**IN THE MATTER OF THE APPLICATION
OF EAST RIVER ELECTRIC POWER
COOPERATIVE, INC. FOR A PERMIT TO
CONSTRUCT A WAPA NORTH BEND TO
PRATT 230-KV TRANSMISSION LINE**

**EAST RIVER ELECTRIC POWER
COOPERATIVE INC.'S ANSWERS TO
STAFF'S FIRST SET OF DATA
REQUESTS TO EAST RIVER
ELECTRIC POWER
COOPERATIVE, INC.**

EL24-011

EXHIBIT 1

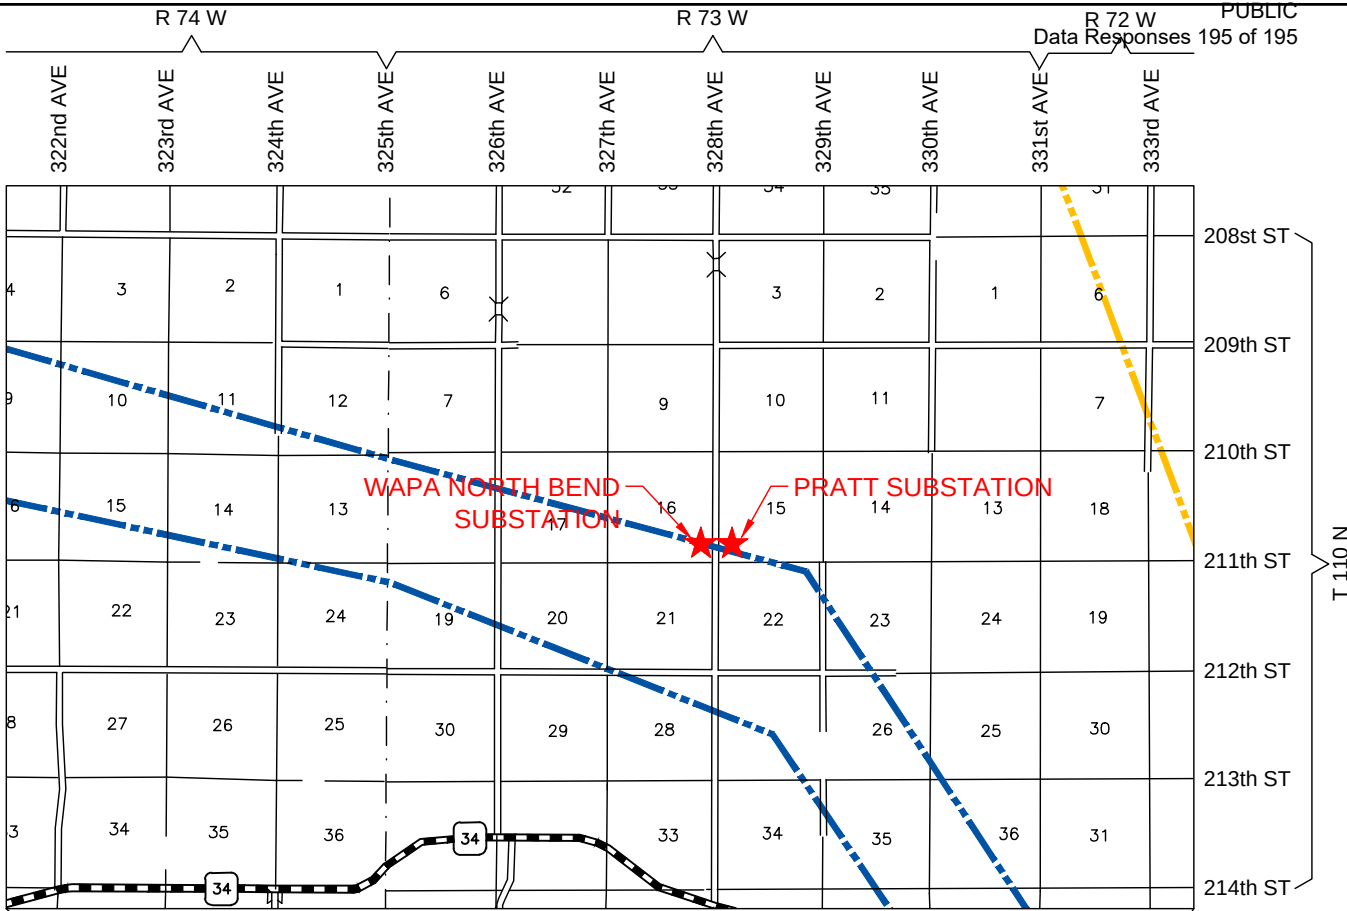
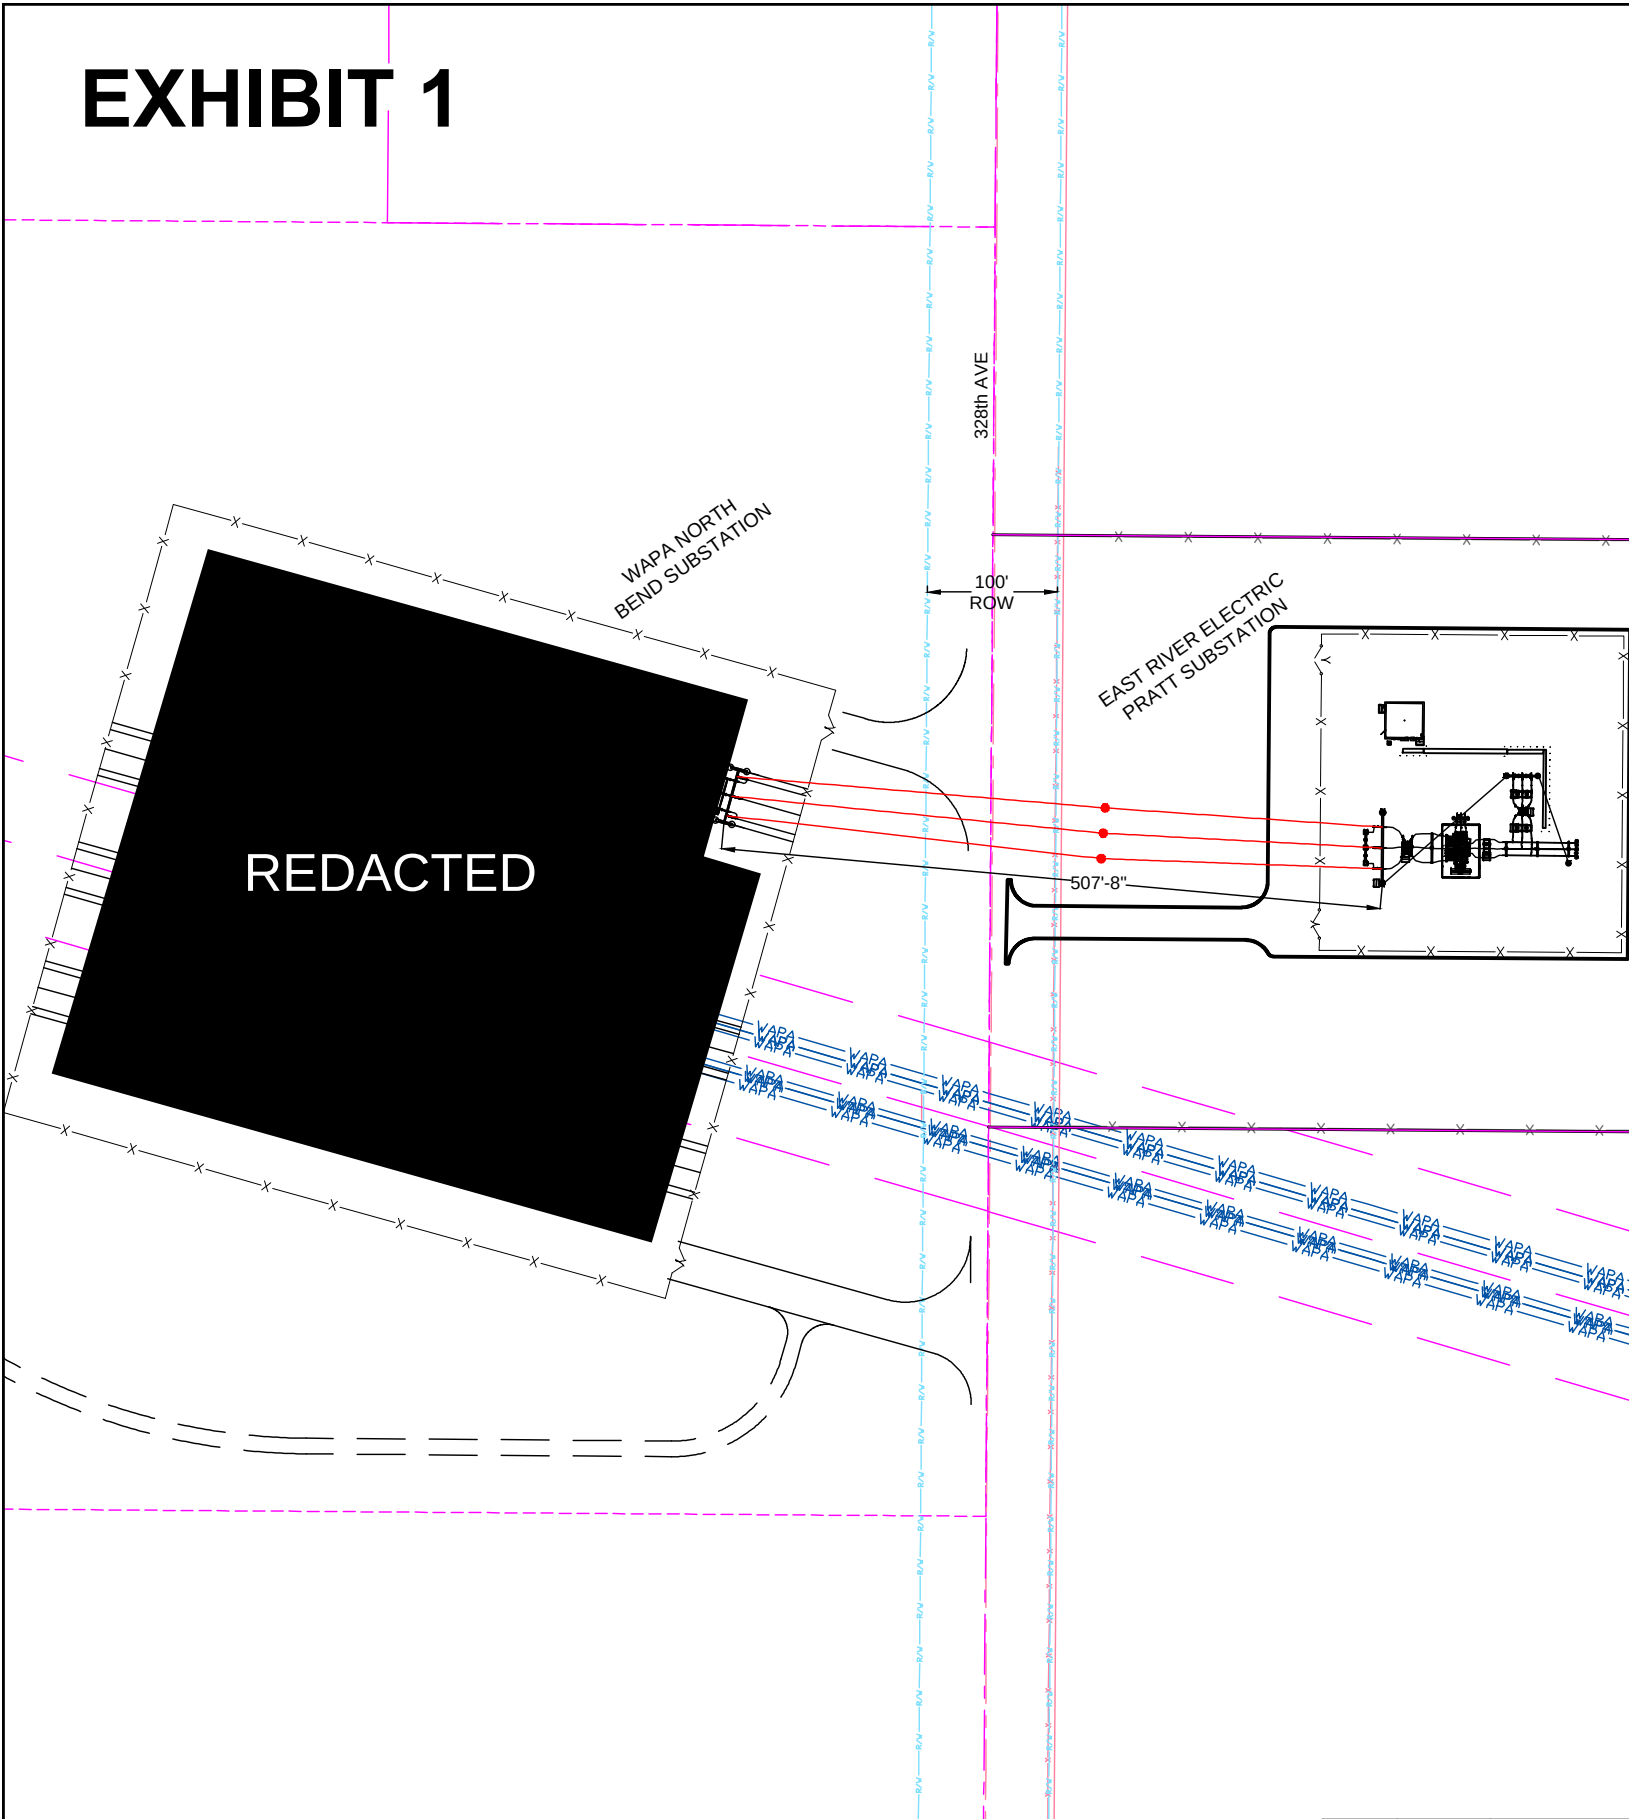
1-2) Refer to Exhibit 1 of the Application. Please verify the accuracy of the substation labels in the Township, Range, and Section call-out, and resubmit if necessary.

*East River Response by Jonathan Aus, Engineering & Planning Services Manager:
See revised Exhibit 1 for map showing the location of the substation using the Township, Range, and Section call-out.*

REV	DATE	DESCRIPTION	CHKD
2	7/18/2024	PUC DATA REQUEST	MLW
1	2/19/2024	PROPOSED LAYOUT	MLW
